# SADDLEHORN RANCH - FILING 2

A PARCEL OF LAND LOCATED IN THE SOUTH HALF OF SECTION 3 AND THE NORTH HALF OF THE NORTH HALF OF SECTION 10  
 TOWNSHIP 13 SOUTH, RANGE 64 WEST OF THE 6TH P.M.,  
 EL PASO COUNTY, STATE OF COLORADO  
**CONSTRUCTION DOCUMENTS**

EPC STORMWATER REVIEW COMMENTS  
 IN ORANGE BOXES WITH BLACK TEXT

**KEY MAP**  
N.T.S.

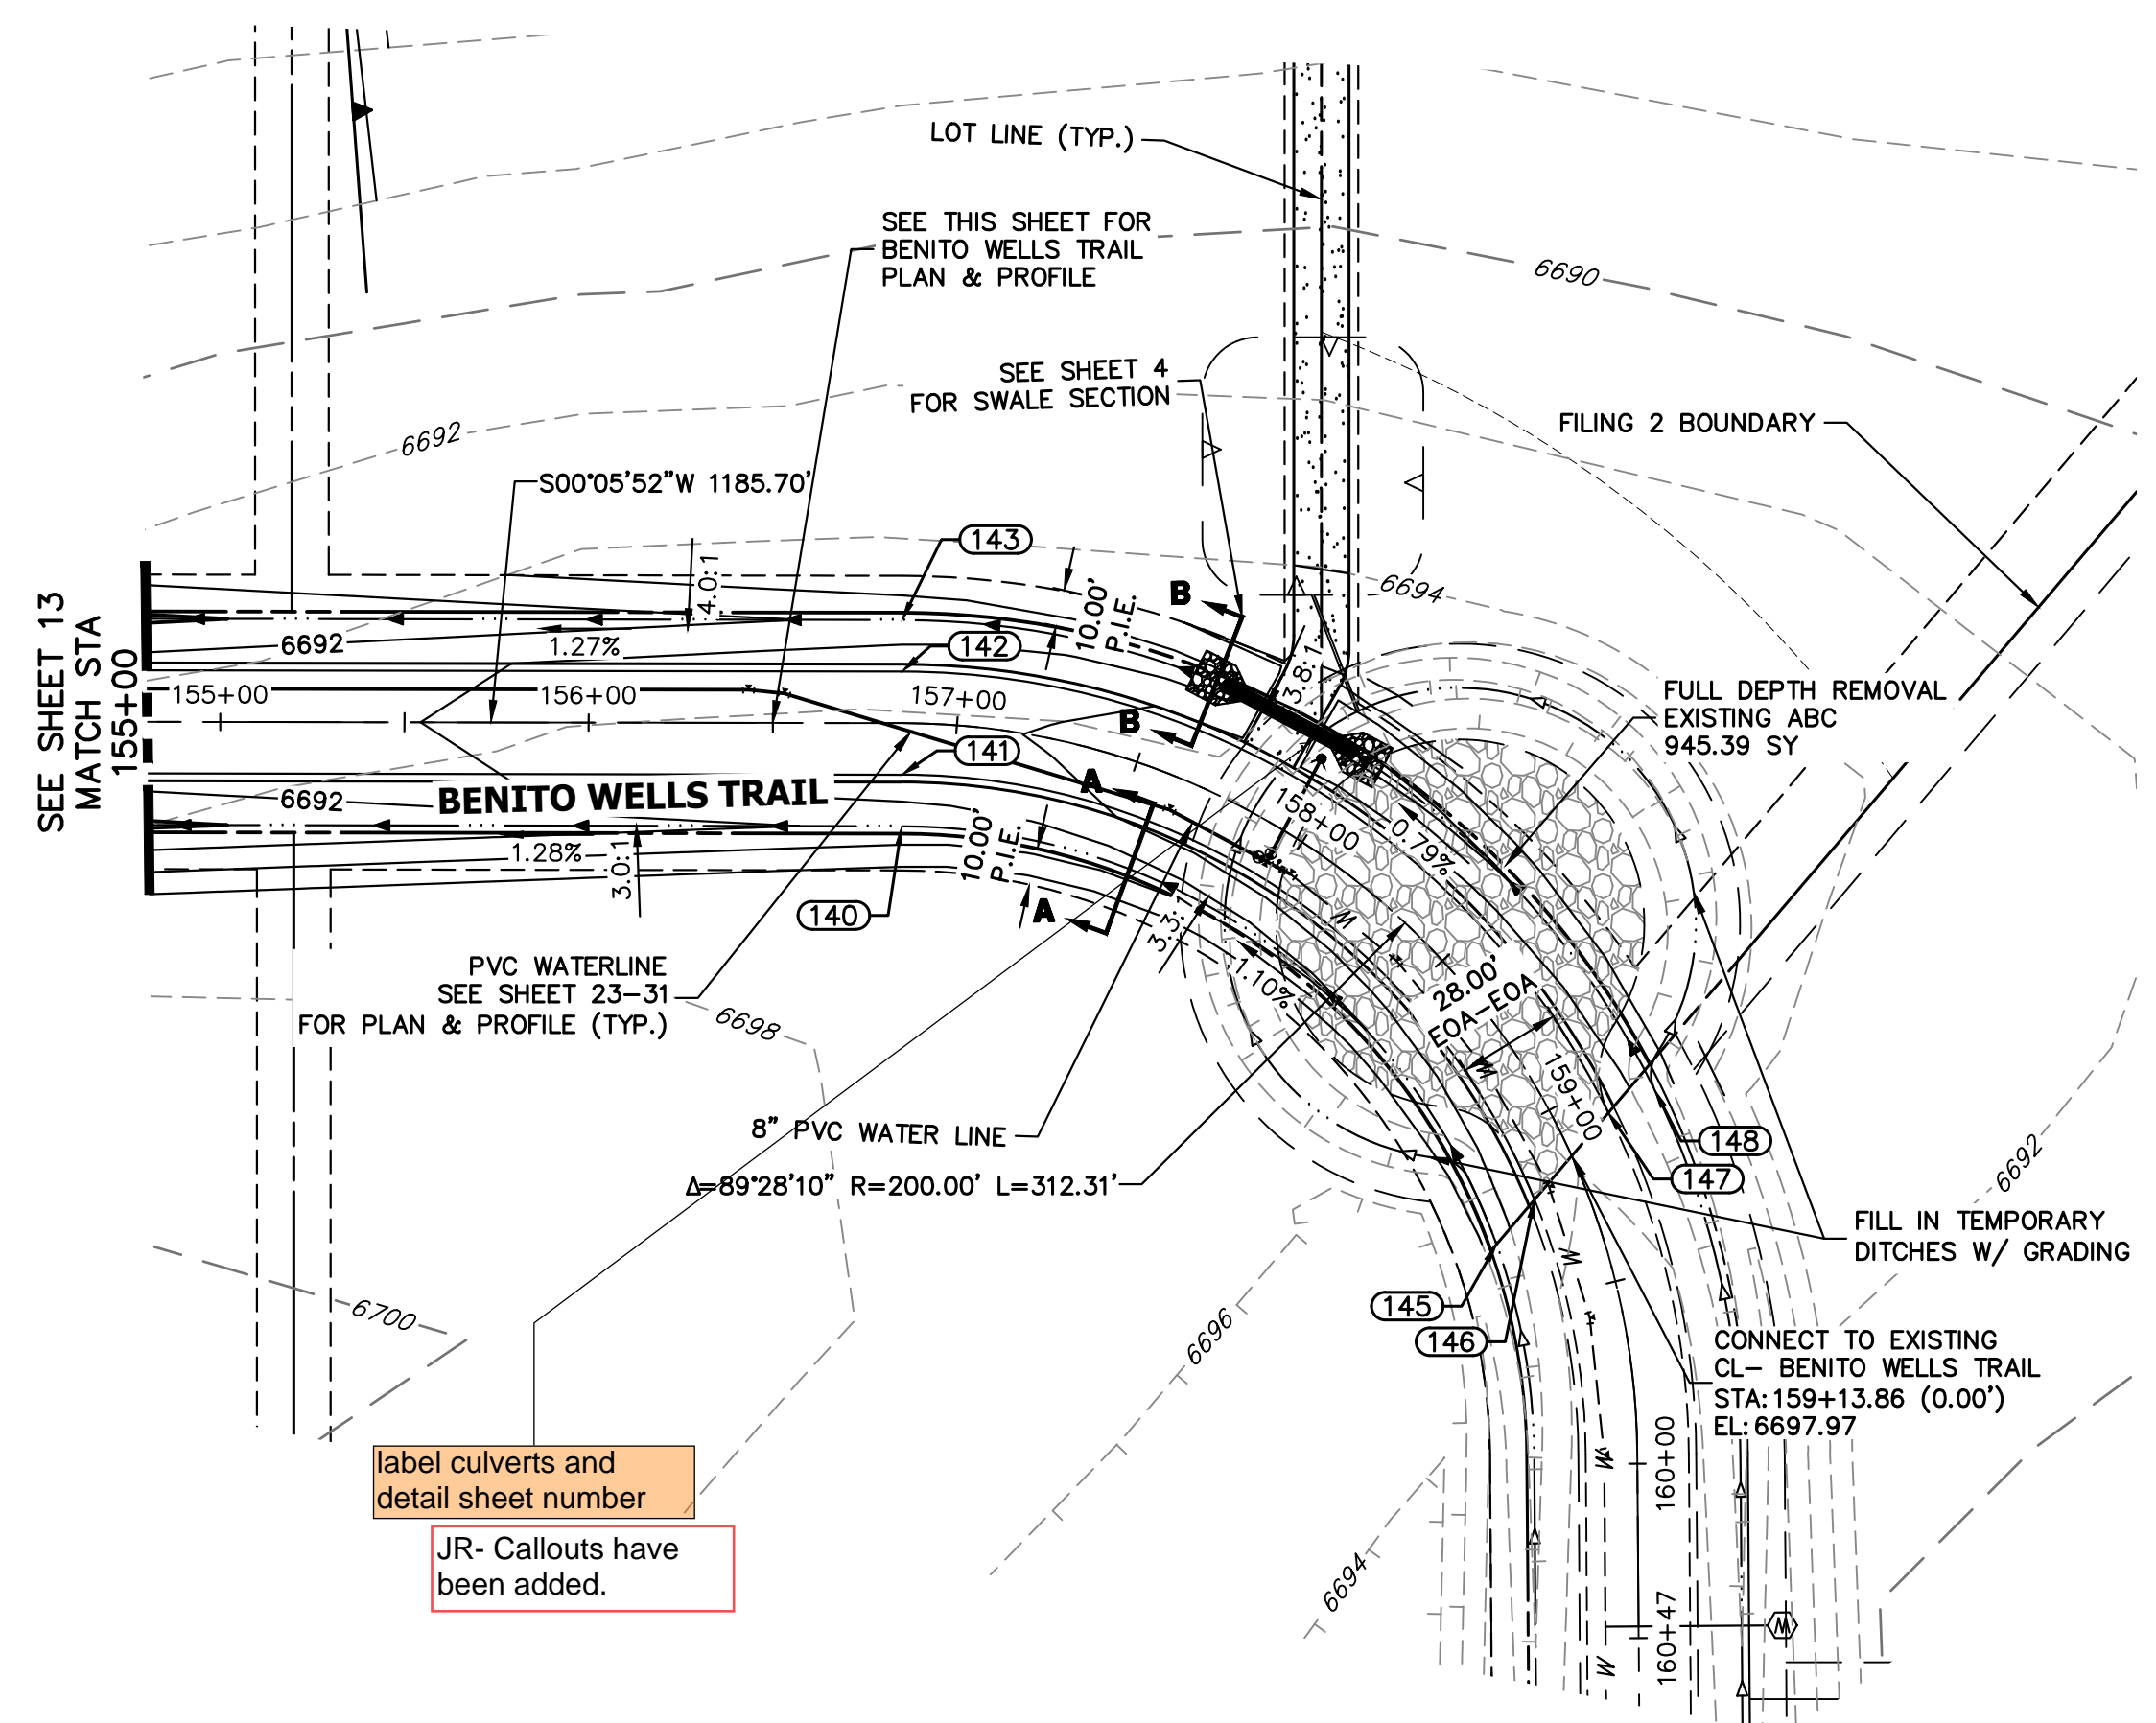
label culverts and detail sheet number  
JR- Callouts have been added.
